**INFORMATIONAL FIELD SERVICE BULLETIN**

FSB Number: LVCCFSB2006-71  
Authors: Darwin Garcia  
Date: February 28, 2006  
Total No. of Pages: 5  
Subject: **Differences between V3\_05 and V3**  
Model Affected: **V3\_05 & V3**  
Level of Repair: 2

Informational FSB to show the major differences between V3\_05 and V3.

**Software**

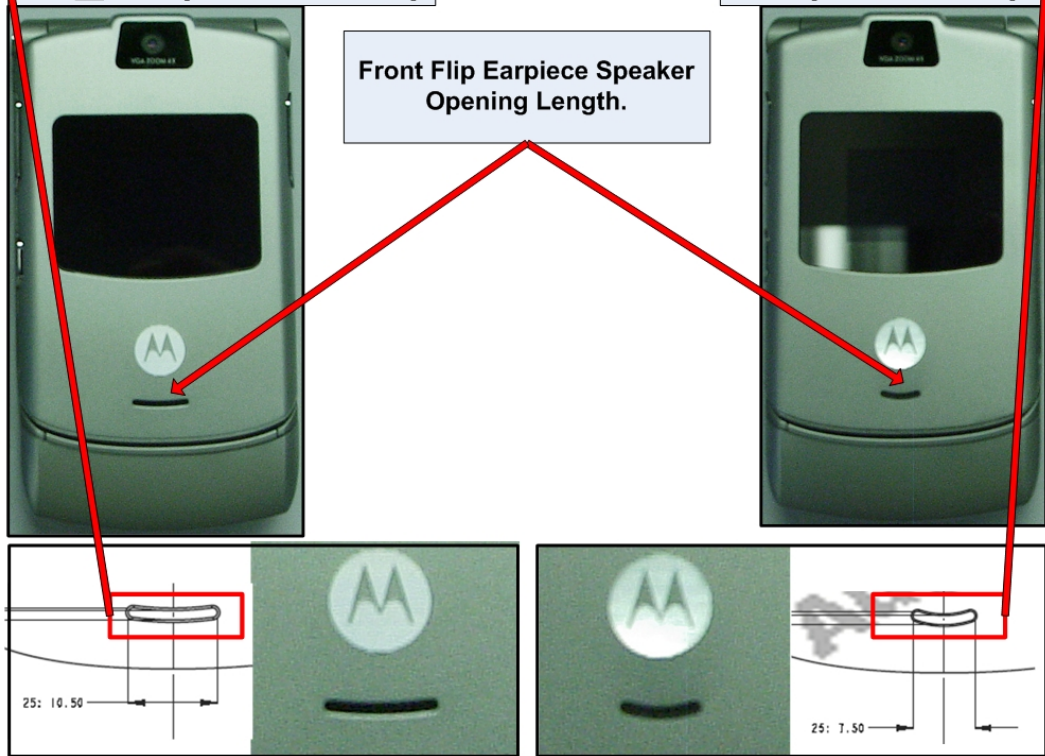
**V3\_05 (R4515)**

**V3 (R374)**

Front Flip Earpiece Speaker  
 Opening Length.

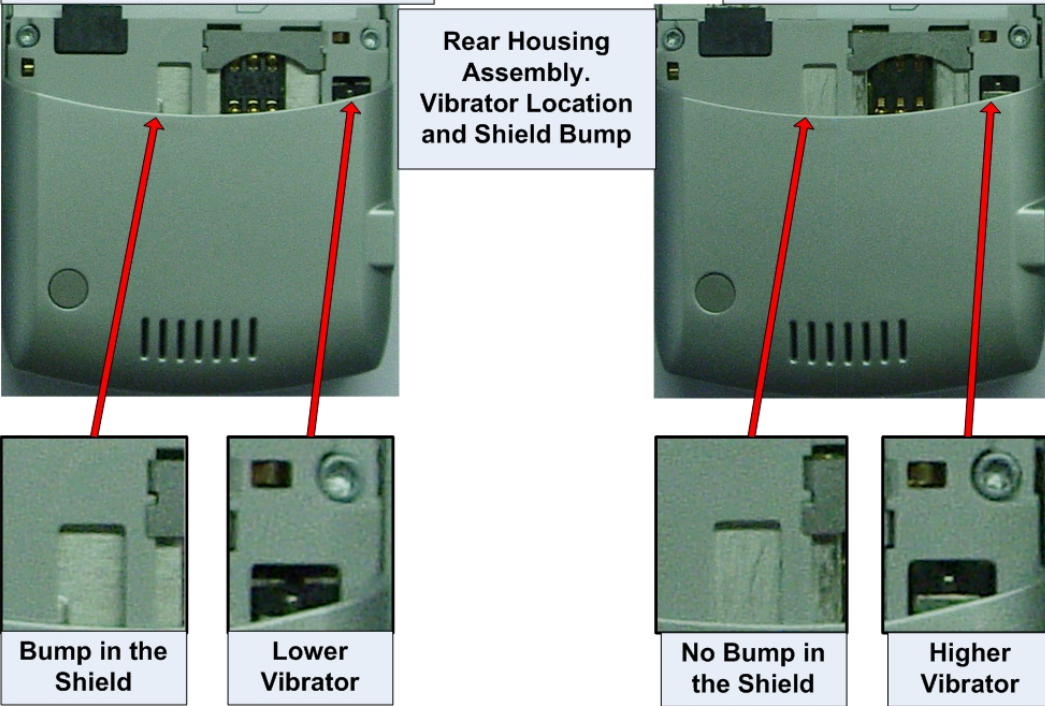
**V3\_05 (10.50mm)**

**V3 (7.50mm)**

Rear Housing  
 Assembly.  
 Vibrator Location  
 and Shield Bump

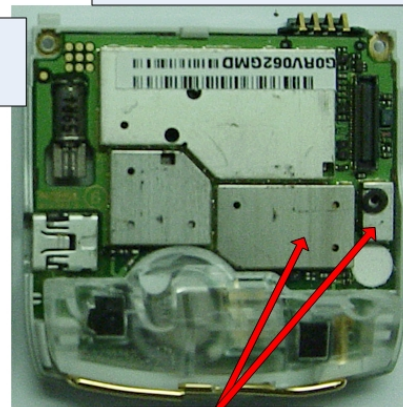
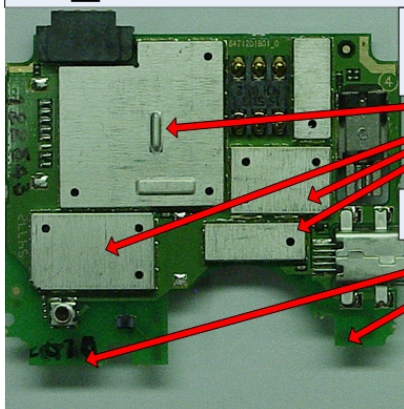
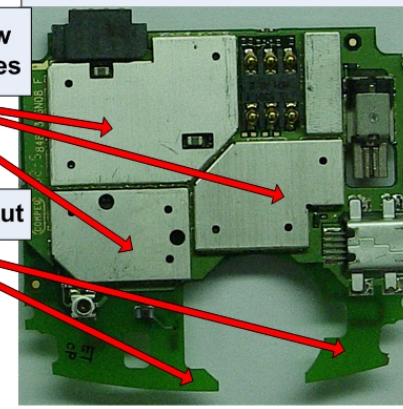
Bump in the  
 Shield

Lower  
 Vibrator

No Bump in  
 the Shield

Higher  
 Vibrator
